Access Compliance Report

Public Rights-of-Way

(Curb Ramps)

Intersection ID: 44065	Main Street: WOODS_CORNER_CT	Cross Street: SEDGEMOOR_LN	Location: S
ADA ID: 8B7C182153EE	Ramp Type: PerpDiag	Initial Pass/Fail: Fail	Overall Compliance: No
Codes/Mitigation Info/Possible Solution		Field Measurements/Component Compliance	
Severity Score: 36.25

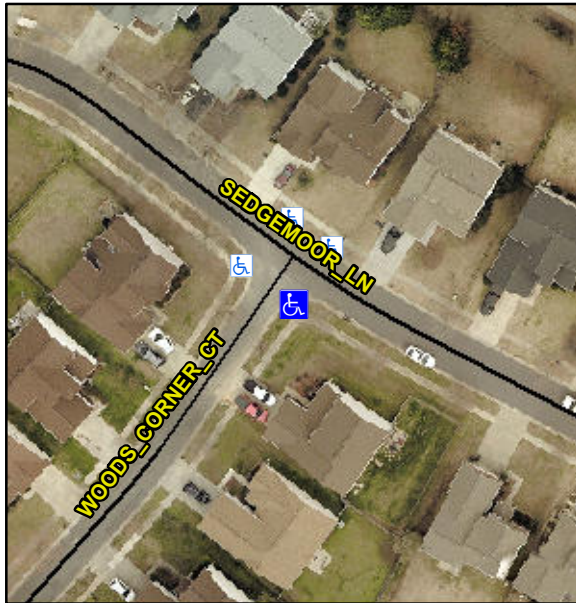
R304.5.1, R304.5.3

Compliance	Description	Data	Compliance	Description	Data
N/A	Ramp Length (in)	78.5	Yes	Ramp Slope (%)	6.2
No	Ramp Width (in)	25.0	No	Ramp XSlope (%)	2.1
N/A	Flare Type LT	N/A	N/A	Flare Type RT	N/A
N/A	Flare Slope LT (%)	N/A	N/A	Flare Slope RT (%)	N/A
N/A	Flare Traversable LT?	N/A	N/A	Flare Traversable RT?	N/A
N/A	Landing Length (in)	N/A	N/A	DWS Provided?	N/A
N/A	Landing Width (in)	N/A	N/A	DWS Contrast?	N/A
N/A	Landing Slope (%)	N/A	N/A	DWS Length (in)	N/A
N/A	Landing X Slope (%)	N/A	N/A	DWS Full Width?	N/A
N/A	Landing Curb? (Y/N)	N/A	N/A	DWS Offset (in)	N/A
N/A	Shared Landing?	N/A			
N/A	Gutter Ponding?	N/A	N/A	Gutter Slope (%)	N/A
N/A	Gutter Lip Ht (in)	N/A	N/A	Gutter X Slope (%)	N/A
N/A	Painted X Walk1?	No	N/A	Painted X Walk2?	No
	X Walk 1 Direction	To NE		X Walk 2 Direction	To NW
N/A	X Walk 1 Width (in)	N/A	N/A	X Walk 2 Width (in)	N/A
	X Walk 1 Slope (%)	1.7		X Walk 2 Slope (%)	2.0
	X Walk 1 X Slope (%)	0.7		X Walk 2 X Slope (%)	0.9

Remove & Replace Curb Ramp With Two New Directional Ramps or Equivalent.
